## EFFECT OF SPIRAL SPACING AND CONCRETE STRENGTH ON BEHAVIOR OF GFRP-REINFORCED HOLLOW CONCRETE COLUMNS

| <b>Manuscript Number:</b>   | CCENG-2684R1  |

## RESPONSE TO REVIEWERS' COMMENTS

Fig. 5. Load–deformation behavior of group A columns

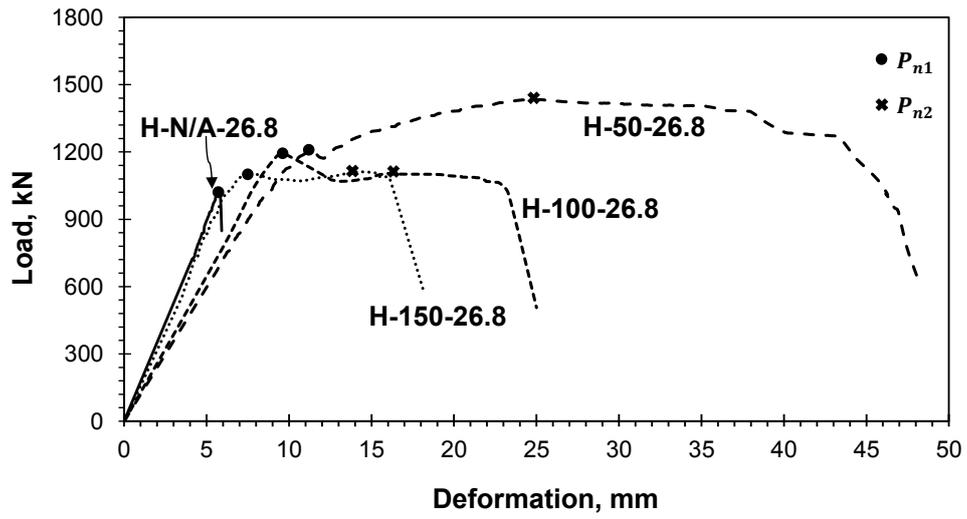
| 14 | L289: define "second peak" and show it on Fig. 5.  | <i>The reviewer's suggestion was implemented in Figs. 5 and 9, and in lines 291.</i>  |

| 4  | Some of the terms such as first peak and second peak should be identified in the figures for clarity.   | <i>This was addressed in the response to <b>comment 14</b> by the associate editor.</i>   |
| 8  | Terms such as first peak and second peak load need to be identified in figures for reader clarity.  | <i>This was addressed in the response to <b>comment 14</b> by the associate editor..</i>  |

**Fig. 6.** Axial and lateral strain versus applied load for Group A columns

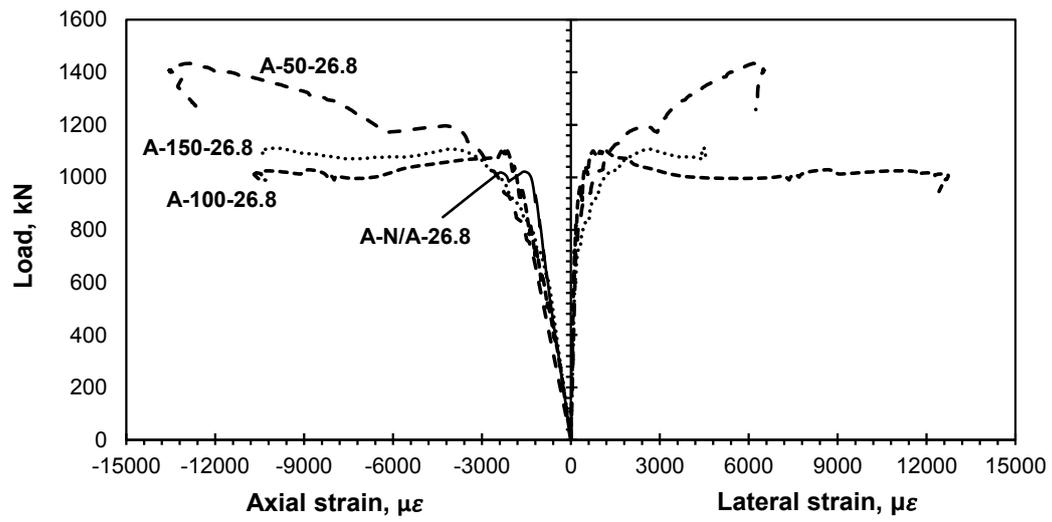
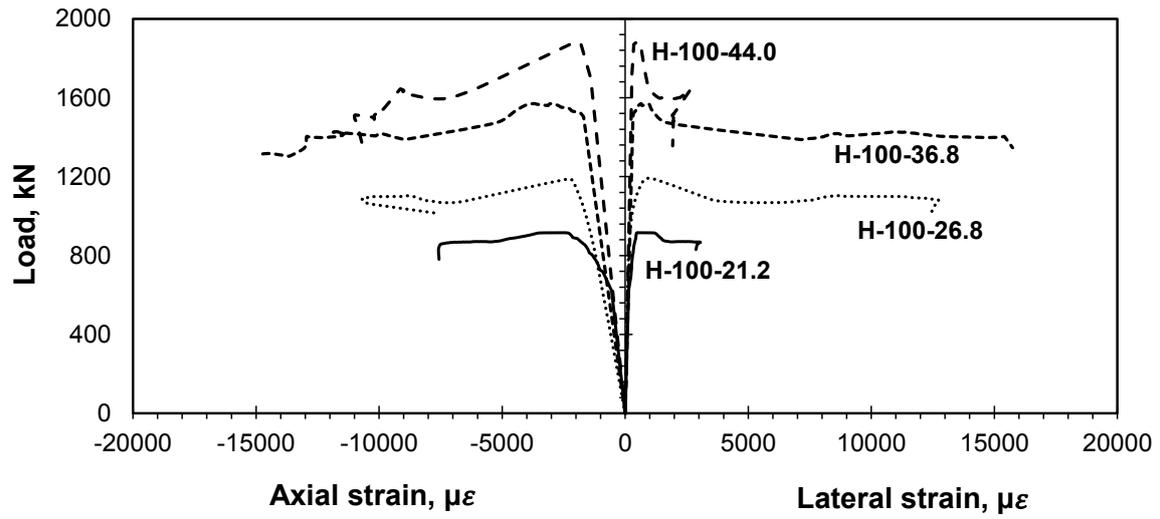
| 16 | Figs. 6 & 10: Lines will not print well in black & white.  | <i>This suggestion was implemented. Figures 6 and 10 were revised by changing the color of all lines to black and white and using different line types.</i>   |
